2007 - 2013 Cadillac CTS-V: GM TechLink: Low Oil Pressure on V8 Engines

Subject: Low Oil Pressure on V8 Engines

Model and Year: 2007 - 2013 CTS-V, Escalade, Avalanche, Camaro SS, Colorado, Corvette, Express, Silverado, Suburban, Tahoe, Canyon, Sierra, Savana, and Yukon models equipped with a V8 engine (RPOs L20, L77, L94, L96, L99, L9H, LC8, LC9, LH9, LMF, LMG, LY6, LZ1)

Source: GM TechLink

Fig. 3

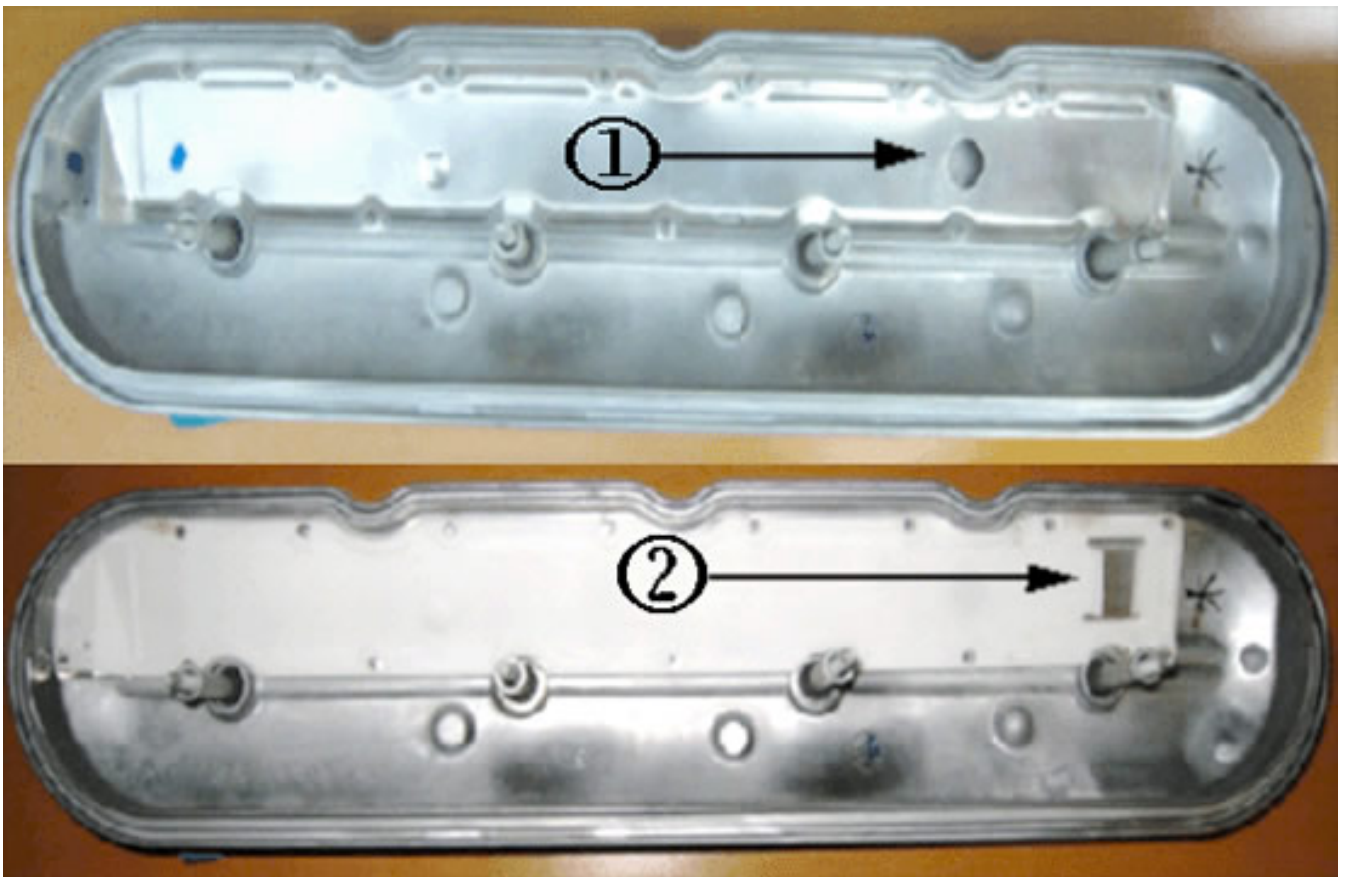
If the engine has been properly repaired and cleaned, inspect the left rocker cover (square baffle) (Fig. 3, #1 – old design; #2 – new design with square baffle) and verify that the baffles can hold water and do not leak. If any leaks

are found, clean and seal the edge of the baffle with RTV, if possible, or replace the valve cover. Thoroughly clean and dry the valve cover before installation and/or resealing.
